STAFF RECOMMENDATION

905 North 12th Street

June 16, 2021

Application: New Construction—Addition and Outbuilding; Partial Demolition

Figure 1. 905 North 12th Street

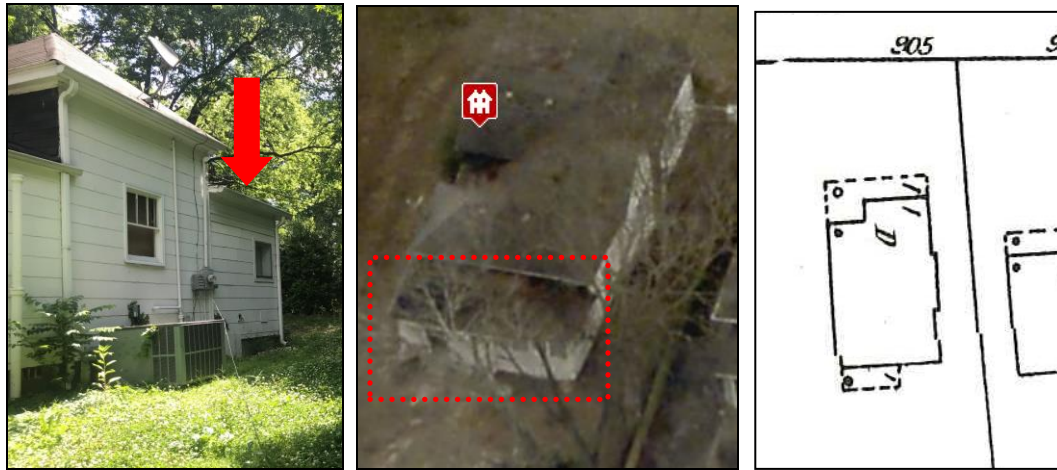
Background: 905 North 12th Street is a c. 1899 Folk Victorian house that contributes to the historic character of the Eastwood Neighborhood Conservation Zoning Overlay (Figure 1). The lot is wide at seventy-one feet (71') and is also zoned RM20.

Figure 9 (Left) is the existing window and Figure 10 (Right) is the proposed door.

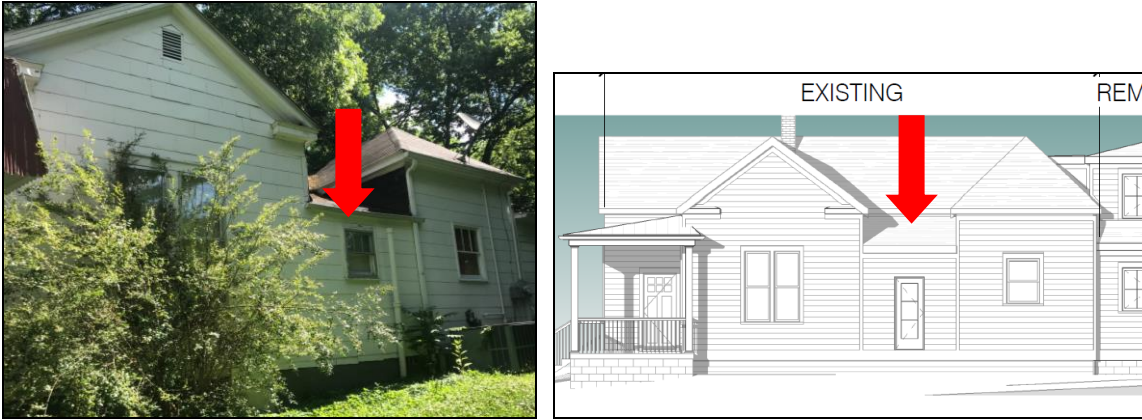
On the right façade, the applicant proposes to change a window opening into a door opening (Figures 9 & 10). The window is located at about the midpoint of the side façade, and it is likely that it is not original to the house. Even if it is original to the house, the short window opening is more utilitarian in design and size than the paired

double hung windows found on other parts of the house's side walls. Staff finds that the alteration of this window into a door opening to be appropriate demolition.

Figure 11. The 1957 Sanborn map. The 1914 and 1951 Sanborn maps show identical footprints.

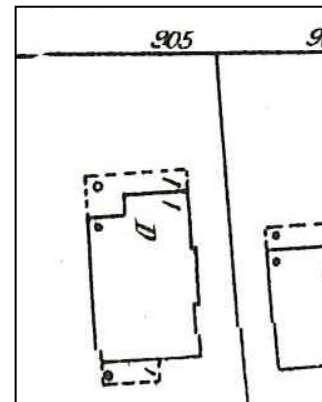
Roof form: As mentioned under "Partial Demolition," the existing front porch will be removed and replaced. No photos of the original front porch have been found, but the 1914, 1951, and 1957 Sanborn maps all show that the front porch originally covered the entire front façade, but was shallower in front of the projecting bay (Figure 11). Today, any foundation in front of the projecting bay has been removed. The applicant is proposing a new low-sloped hipped roof that just covers the recessed portion of the front façade. Staff finds this to be appropriate since the design of the original porch is not known, and the new porch has a simple design that is in keeping with other porches on similar houses in the immediate neighborhood.

4
3 **SIDE B**
1" = 10'-0"

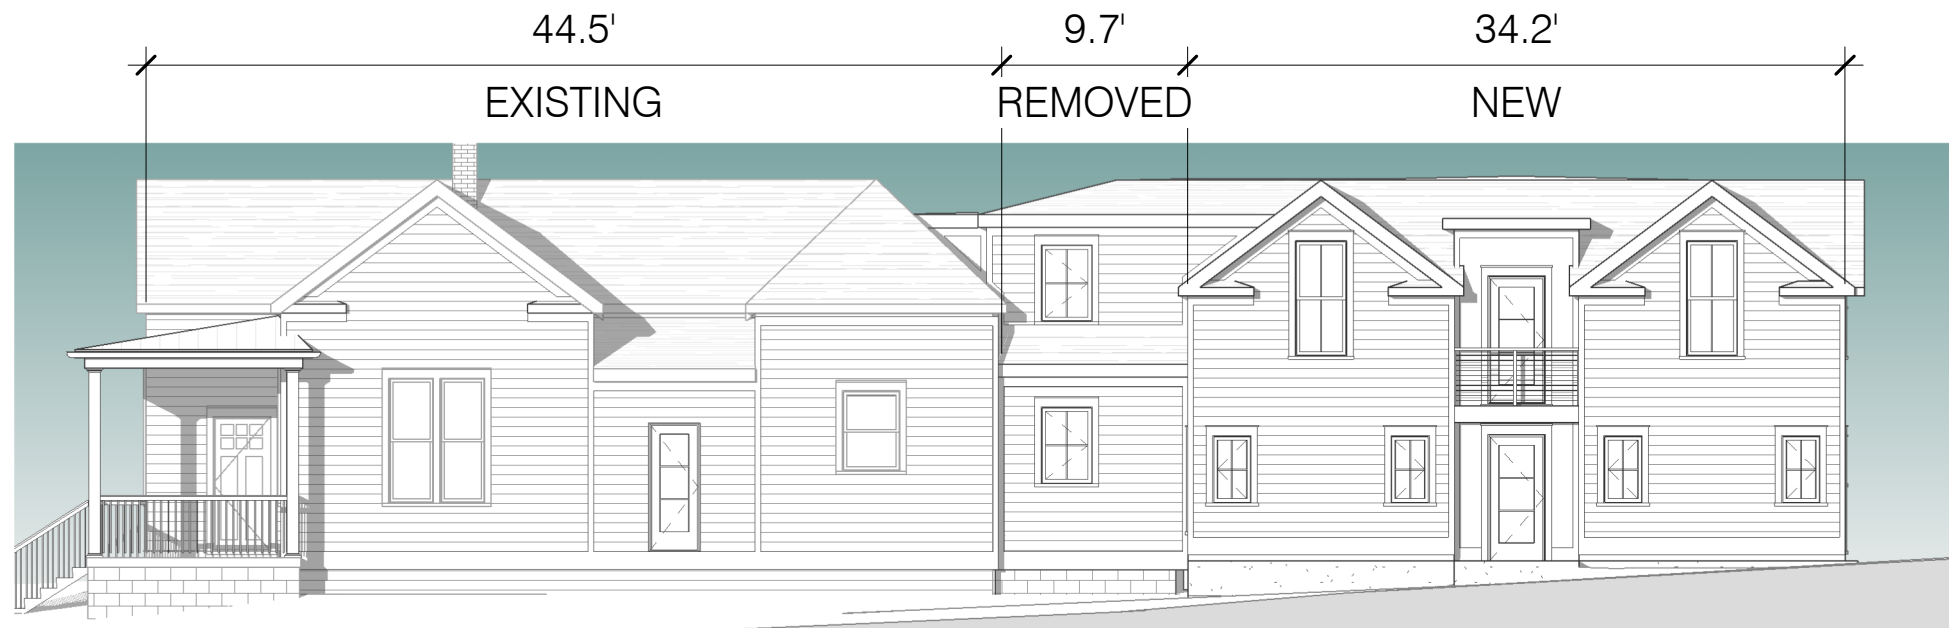
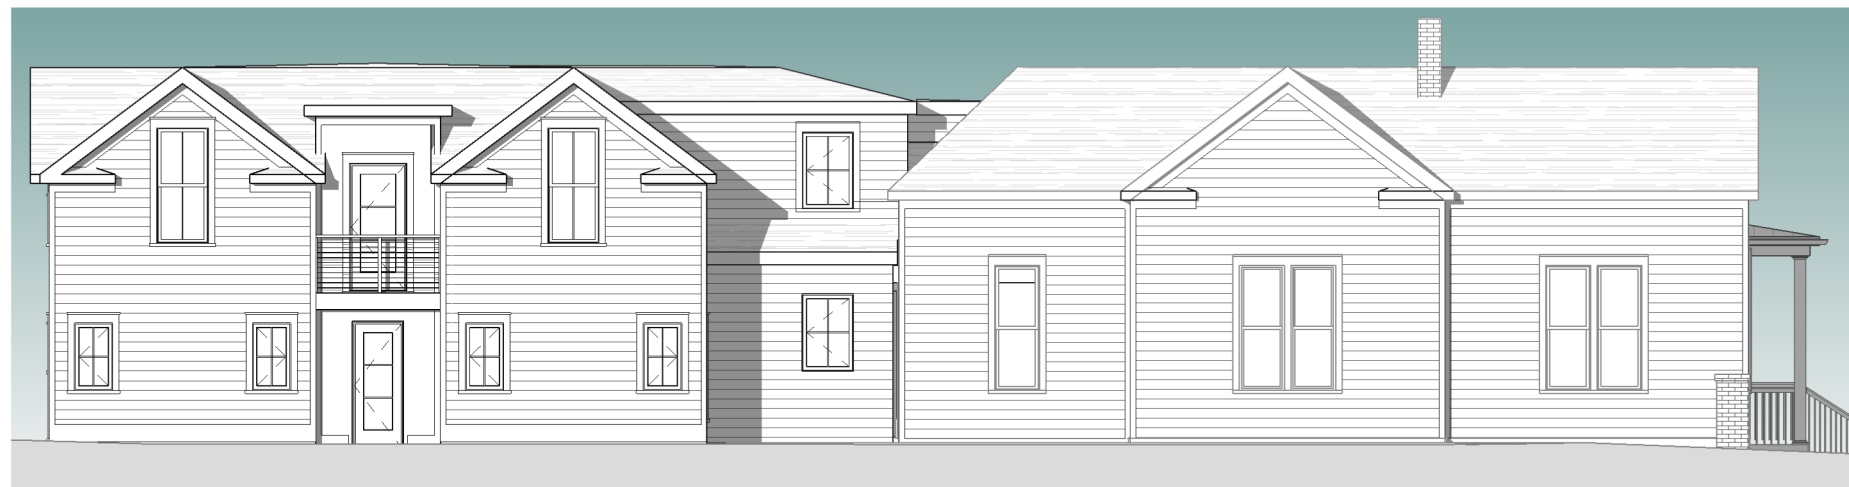
Demolition: The applicant plans several actions which are considered partial demolition. First, the applicant intends to remove an existing rear addition (Figures 2 & 3). The addition's date of construction is unknown, but the 1914, 1951, and 1957 Sanborn maps all show a smaller covered porch in this location, so the addition is post-1957 (Figure 4). The existing addition's footprint is different than what is seen in the historic maps, and it has a roof form separate from the main roof form of the house. Staff finds it does not contribute to the house's architectural integrity and that its removal meets the guidelines.

Height & Scale: The addition is inset one foot (1') from both back corners of the historic house for a depth of ten feet (10'). After this point, the addition steps back out on both sides to be wider than the historic house. Staff finds that a wider addition meets the design guidelines in this instance because the lot is wide at seventy feet (70') and the house is just twenty-six feet (26') wide. The addition will extend six feet, six inches (6'6") wider than the house on both sides.

Although typically MHZC encourages additions to go wider only on one side, staff finds that this footprint meets the design guidelines for several reasons. First and foremost, the design guidelines allow for wider additions to extend wider by one-half the width of the historic house. In this case because the house is twenty-six feet (26') wide, so an addition could go a total of thirteen feet (13') wider. The applicant has split this dimension so that it extends six feet, six inches (6'6") on both sides rather than thirteen feet (13') wider on one side. This will lessen the visual impact of the wider addition on the historic house. Second, the addition in other respects meets the design guidelines – it is not taller than its historic house. Lastly, the design guidelines allow for additions to go wider when either the lot is wide or the house is narrow and less than thirty feet (30') wide. In this case, the site is meeting both conditions – the lot is wide and the house is narrow.
